Prelim Response to BLM Letter 2-13-15

m/037/0088

LVMC Preliminary Review of BLM Response Letter 2-13-15

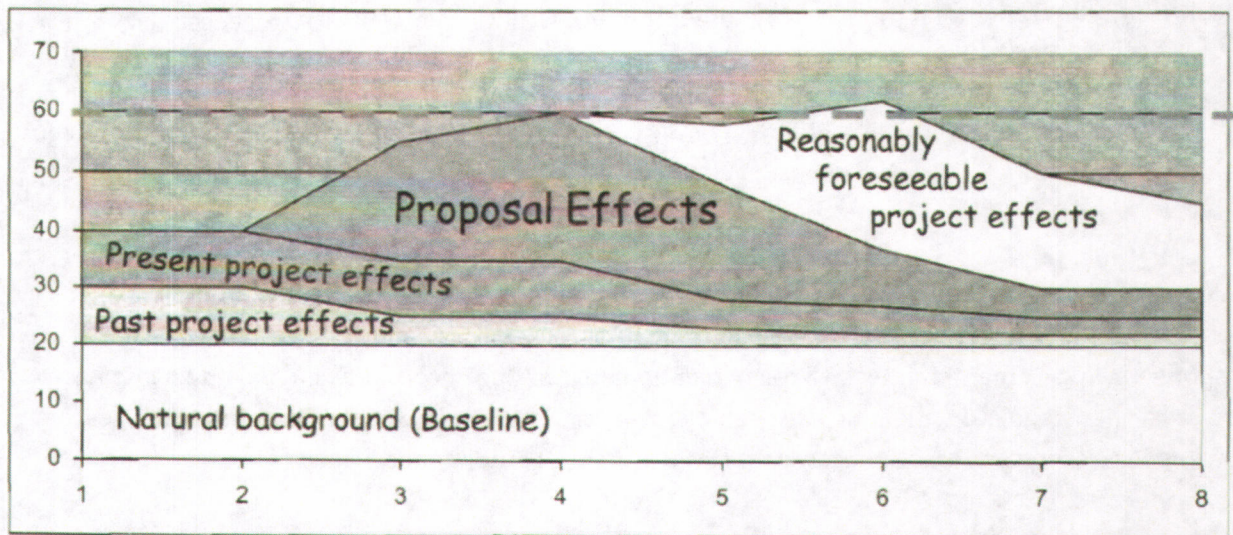
Lisbon Valley contends that the data collected and presented to date clearly shows that there is no uncertainty of impacts and no scientific controversy to post-mining groundwater quality associated with the partial backfilling modification. However, the record indicates that uncertainty remains. For instance, selected column tests (kinetic) were not conducted for a sufficient time period to provide a representation of quasi equilibrium conditions with respect to uranium concentrations in the pore fluids. Even though the BLM approved a *Work Plan for Additional Geochemical Testing of Lisbon Valley Mine Waste Rock* on February 12, 2014, the test was inconclusive in that the kinetic test was not run to the point of convergence¹. Because of the short duration of the test, the concentration of uranium that can be potentially released by Bed 15 is indeterminate.

The kinetic testing conclusively showed that the concentration of uranium released from Bed 15 was below the background concentrations in groundwater below the Centennial Pit. It was not necessary to continue running additional pore volumes through the columns to reach this conclusion. Additionally, a mix of Bed 14 and Bed 15 materials will comprise the backfill, and the uranium concentration in leachates from the mix of Bed 14 and Bed 15 will be significantly lower than leachates from the monolithologic Bed 15 columns. The uranium concentrations from a proposed mix of Bed 14 and Bed 15 and from Bed 15 itself are below the protection levels listed in the Ground Water Discharge Permit for wells below the Centennial Pit. As reported to BLM in the letter to Kent Hoffman, dated 12-30-14:

The raw unadjusted concentrations from the monolithologic Bed 15 leachates do not represent the expected concentration of groundwater in backfill because the proposed action includes 7% Bed 15 and 93% Bed 14. To correctly predict the backfilling concentration, the column leachate results must be mixed in this ratio and equilibrated. A simple mixing calculation of 7% Bed 15 and 93% Bed 14 produces uranium concentrations of 0.0174 to 0.0213 mg/L for PV0.5 to PV3. As shown in the attached table, the expected groundwater concentration in the backfill under the proposed action is significantly lower than the permit maximum background concentrations for uranium at MW2A, SLV1A, PW-3, and MW96-7A and also well below the drinking water standard of 0.03 mg/L.

There is no uncertainty on this point.
